TRUCK, LIGHT, MC2 LAND ROVER 110 - ALL TYPES

FITTING OF IMPROVED CHASSIS LONGITUDINAL RAILS

MODIFICATION INSTRUCTION

Figure 1 - Longitudinal Rail Position

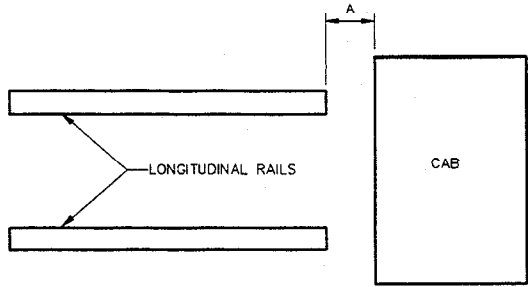
- a. Remove mudguards.
- b. Remove module from the vehicle, as detailed in the relevant variant EMEI (see Para 2).
- c. Remove rear tool boxes, jerry can holder and battery carrier.
- d. Steam clean the underside of vehicle and rear chassis area.
- e. Measure and note distance A, shown in Figure 1, between rear of cab and front of longitudinal chassis rails for ease of refitting new rails.
- f. Using an angle grinder, remove the welds securing the two longitudinal chassis rails and remove the rails.

Figure 2 - Relocation of Module Wiring Plug Position

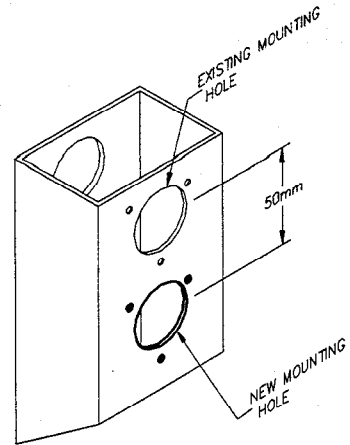
- k. Rework the right-hand rear chassis upright by lowering the plug position 50 mm, on the inboard side, as shown in Figure 2.

EMEI Vehicle G 227-1 shows the relocation of the 7-pin auxiliary plug to the inboard position. The plug is lowered a further 50 mm by this action.

Figure 3 - Position of Channels

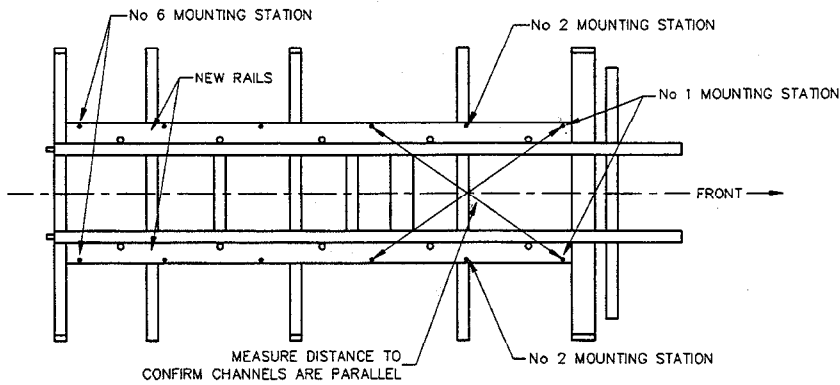
- l. Position the new longitudinal rails (Item 1 from Table 3) in place. Pay particular attention to the hole to hole transverse dimensions and front and rear locations.
- m. Check to ensure diagonal relationships between rail holes are within +/- 1.5 mm, as shown in Figure 3.
- n. Tack weld the rails to the uprights, using low hydrogen welding rods (Item 1 from Table 2).

The six 'D' shaped cup washers (Item 5 from Table 3) are fitted at stations where the mounting bolt is close to the upright posts, usually posts 1, 2 and 6, as shown in Figures 3 and 5.

Figure 4 - Position of Welds

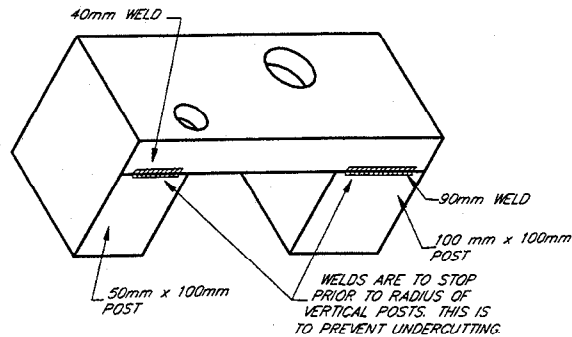
- o. Recheck dimensions and alignment.
- p. Weld rails, as shown in Figure 4, pay particular attention to ending of welds (to minimise weld undercuts).
- q. Clean all welds, and the area around the module wiring plug.
- r. Paint all ground and weld affected areas with Corium 709 (Item 2 from Table 2).
- s. Refit the 7-pin auxiliary plug and harness assembly.
- t. Refit the tool boxes, battery box.
- u. Position jerrycan holder, do not bolt jerrycan holder to chassis.
- v. Fit the mudguards and use them as a template to mark new mounting hole position in the new longitudinal rails.
- w. Remove the mudguards and drill 6 mm holes in marked positions on the longitudinal rails.
- x. Refit module as detailed in relevant EMEI (Para 2).
- y. Using Items 2 to 7 listed in Table 3, secure the module using mounting fixtures, as shown in Figure 5.

Figure 5 - Mounting Fixtures

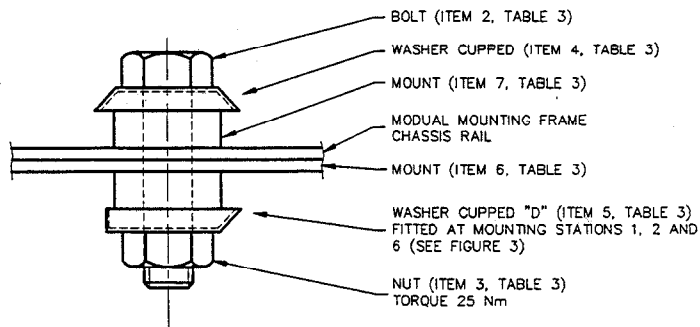
Normal cupped washers (Item 4 from Table 3) are fitted, as shown in Fig 5. Some of the polyurethane mounts may require modifications to be fitted on mounting bolts close to upright posts.
